TESTIMONY – CAPITAL CRESCENT TRAIL/LITTLE FALLS PARKWAY CROSSING
HAROLD PFOHL, ON BEHALF OF
THE CITIZENS COORDINATING COMMITTEE ON FRIENDSHIP HEIGHTS

JUNE 13, 2019

EXHIBIT 1 LITTLE FALLS PARKWAY/ARLINGTON ROAD CORRIDOR TO DOWNTOWN BETHESDA, AND OLD GEORGETOWN RD.

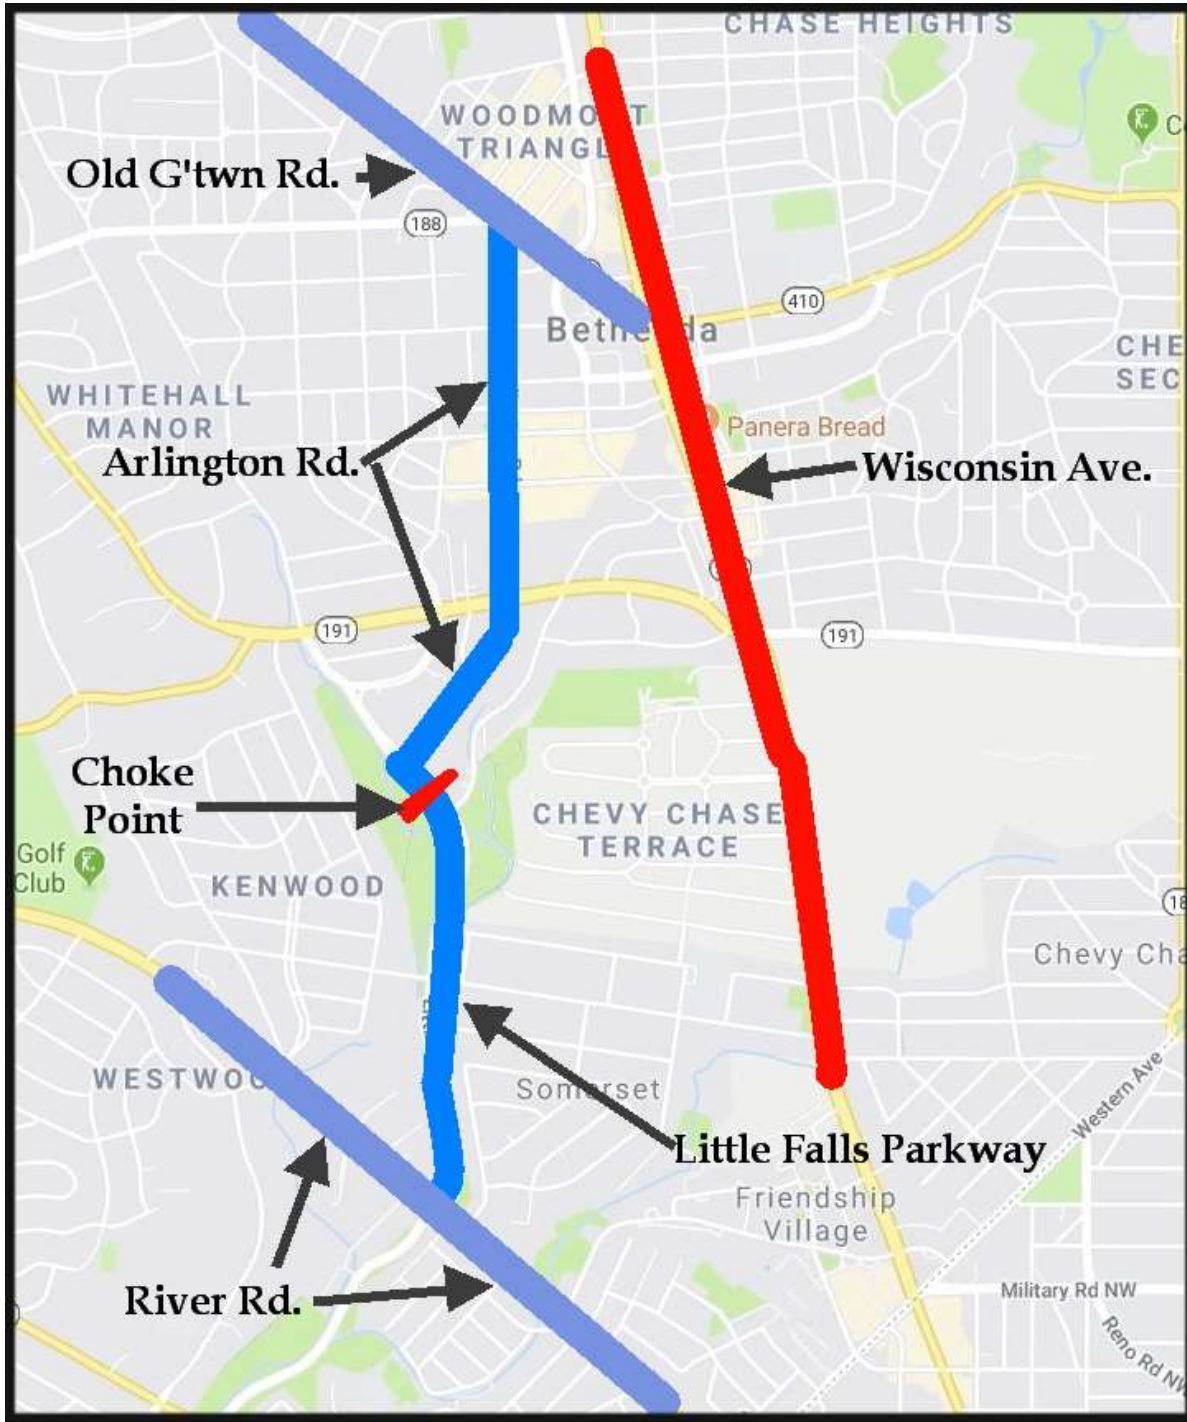
The severe congestion on Wisconsin Avenue through Bethesda results in aggravation, frustration, and lost time for all of us who drive it. By contrast, the combination of Little Falls Parkway and Arlington Road has worked reasonably well. But, the planned crossing proposal imposes a permanent two lane chokepoint on a roadway that is four lanes wide from River Road through Bethesda all the way to Old Georgetown Road. This is in the name of safety when it is not the safest solution as David has pointed out. Furthermore, frustrated drivers coping with chokepoints and associated delays are not safe drivers. See Exhibit 1 below.

I've been repeatedly told by the Parks Dept. that the Parkway is properly a park and should be returned to a primarily park condition. That logic is used to justify lane removal and landscaping of that removed lane for approximately 130 ft. of roadway between the Bethesda public pool and the Arlington Rd./Little Falls Parkway intersection. That rationale is a stretch. There is nothing there whatever that can be enjoyed as a park other than a tiny amount of green space that one will pass by. To utilize the creation of 130 ft. of green space as rationale to impose a chokepoint on a major traffic corridor several miles in length defies common sense.
